5B Prince Arthur Road
London, NW3 6AX

Basement Impact Assessment
Audit

For
London Borough of Camden

Project Number: 13398-31
Revision: F1

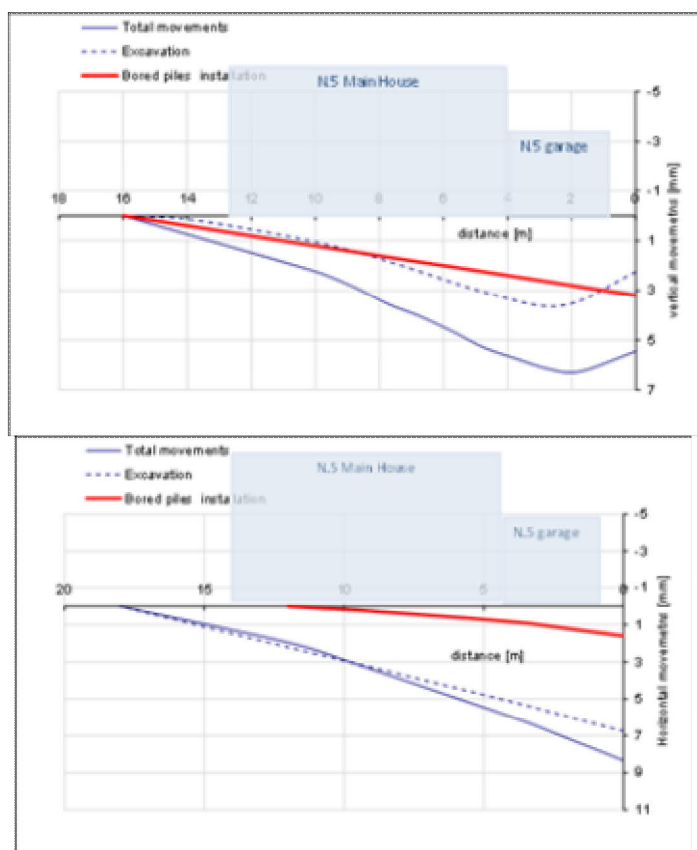
In the Addendum BIA, reference to research projects is made where it is stated that the press-in piling induces up to 10-15 times less ground vibration compared to traditional sheet pile installation techniques and, as such, significantly lower ground movements are expected. While this may be true for soft clays or very loose fine granular deposits, it may not be the case for dense granular deposits and ground conditions like the ones existing at the subject site. Further, CIRIA C760 refers to at least one case study located in Central London, where press-in sheet piles wall installation resulted in monitored ground movements of some 20mm to 30mm

uplift along all four sides of the planned excavation. The ground heave reported in CIRIA's report was due to water jetting used to assist driving during the sheet piles installation and because the water could not permeate through the dense gravels fast enough resulting in build-up of pressure and ground heave. It is noted that a considerable thickness (at least 4.20m thick) of medium dense sand and gravel layers are present at the subject site which means that driving assistance of the sheet piles via water jetting or pre-augering cannot be ruled out during construction. Further, CIRIA C760 report (published at a later date than the research papers quoted in the Addendum BIA) although discusses the press-in technique, it does not make any allowance or suggestion to consider reduced ground movements due to wall installation when this particular technique is used. In the light of the above and with the view of adopting a conservative approach as required by CPG Basements, the GMA and damage assessment is requested to be revised in order to consider ground movements due to wall installation as per CIRIA C760. This will close out this query, subject to potential damage being within the acceptable by LBC guidance criteria or mitigation measures being proposed as required. An alternative way of closing out this query would be to provide a statement from a well-known specialist contractor that press-in piles will not cause any ground disturbance/movement during application of the press-in piling at this particular site.

The database in CIRIA C760 does not include movements related to the installation of sheet pile walls. We shall point out that the unpublished case of 20—30mm uplift mentioned above is not reported in Figure 6.6, neither as horizontal nor as vertical non-normalised ground movement, nor it is reported as normalised vertical movement in Figure 6.8b; but it is reported in Figure 6.8a as normalised horizontal movement. Being a case of uplift, it is unclear what the reported horizontal movement in Figure 6.8a are and their reliability is questionable. We shall also point out that excluding this questionable case and the Bell Common data, also notoriously unreliable, all data of horizontal movements induce by pile installation scatter around zero. The most recent publication by Ball et al. 2014 confirm that this is the case.

We are reluctant to adopt the envelopes in Figure 6.8 for the assessment of movements induced by the installation of sheet piles using press-in techniques, because the database in Figure 6.8 is for bored piles, whose mechanism causing ground movements is different from the mechanism of driving or press-in piles. In fact heave rather than settlements could be more reasonably expected from a press-in mechanism, which

would be compensated by settlements due to pre-augering, if any. Section 5.2.2 of GCG's GMA states: *"Provided that a competent and experienced contractor is employed, the installation of sheet pile walls is not expected to cause significant ground movements [...] these would be localised immediately behind the wall and could be expected to cause upward ground movements that can be conservative estimated to be up to about 5mm"*. We stand by this statement. We believe that the wall installation carried out by competent contracts will cause negligible movements. If we considered 5mm heave at the back of the wall and conservatively assumed that it would reduce linearly within 5m distance (although we believe that this distance would be much shorter), then the vertical movements on No.5 would be predicted to be as in the figure below:

The wall installation could cause some minor uplift of the garage of N.5, which would tend to tilt away from the site. This might in fact result in some shearing of the walls that could cause cracks at the wall junctions and might cause a potential damage at this stage that classifies well within Category 1. The excavation for the new basement could then cause settlement that would compensate the initial heave, so that the garage would tend to return to its original position. The main house is unlikely to be affected by the installation of the retaining walls and the vertical and horizontal movements discussed in the GCG's GMA report apply. I shall point out that the movements across the garage estimated above are less conservative than those reported in GCG's GMA, which had considered a more conservative approach to the issue.
